| <b>Title of Change:</b>        | To update the dimension on datasheet of FGY75N60SMD with case outline 340CD                                                                                   |
| <b>Change Category:</b>        | To correct the package dimension on Datasheet                                                                                                                 |

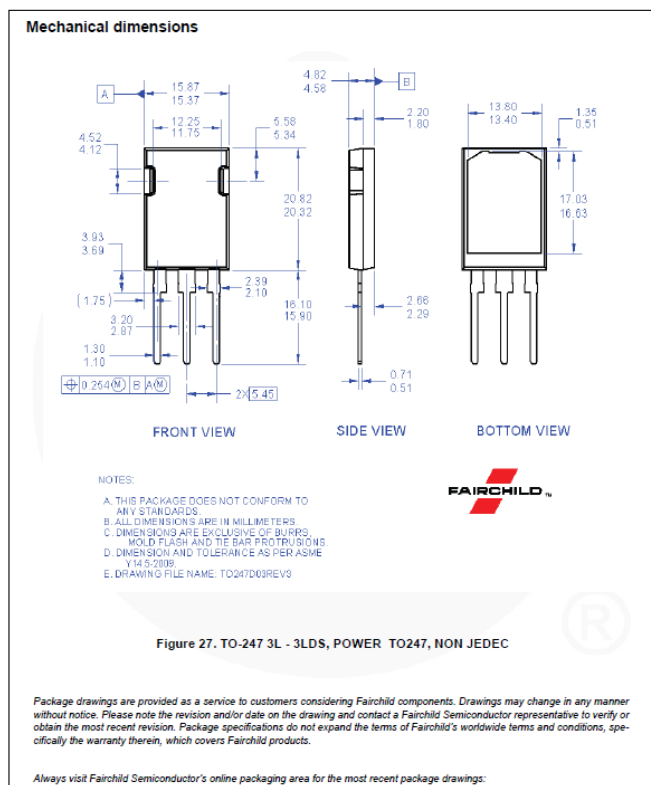
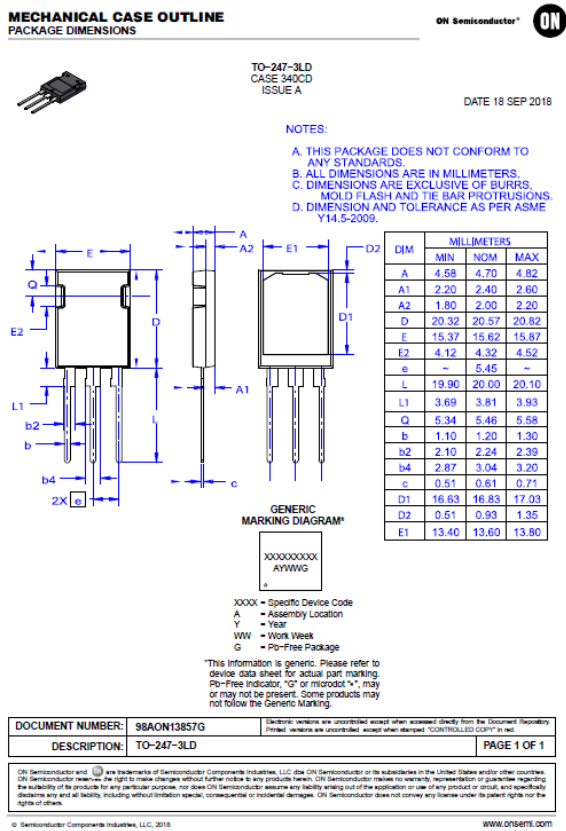
This product bulletin is released to reflect the correct case outline from 340CE to 340CD for FGY75N60SMD, due to an unforeseen error found in the datasheet.  
There is no physical dimension change to the product, thus, the change will not impact form, fit, or function of product.

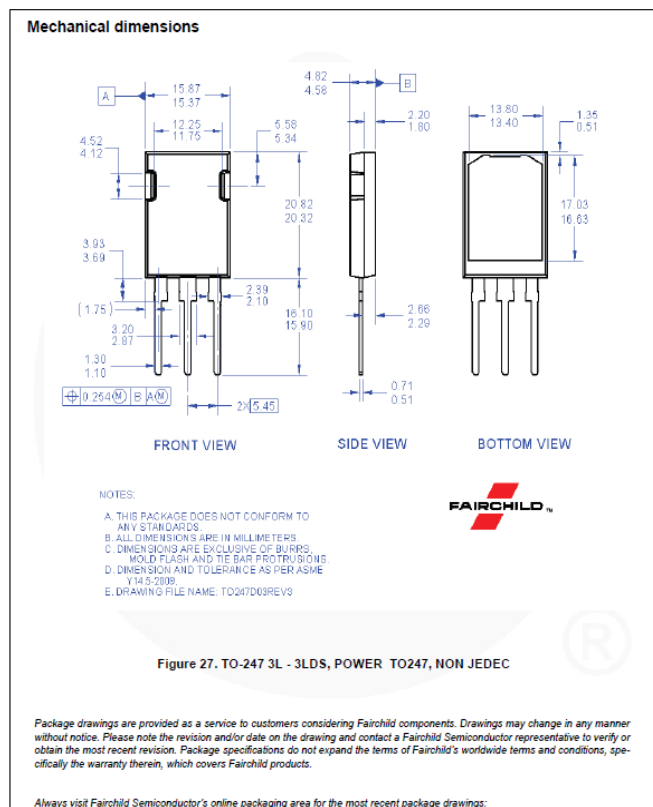
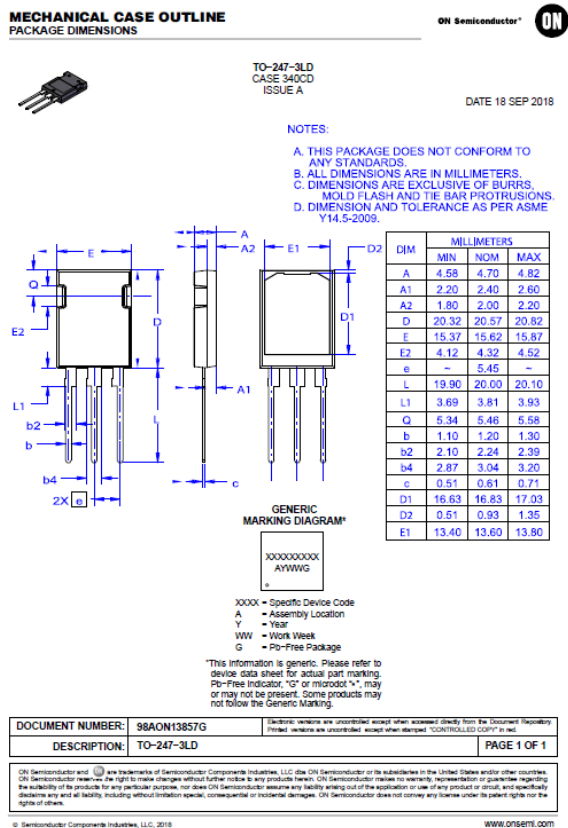
この製品速報は、データシートに予期しないエラーが見つかったため、FGY75N60SMD の 340CE から 340CD までの正しいケース外形を反映するためにリリースされました。

製品に物理的な寸法の変更はありませんので、この変更は製品の形状、適合性、または機能に影響を与えません。
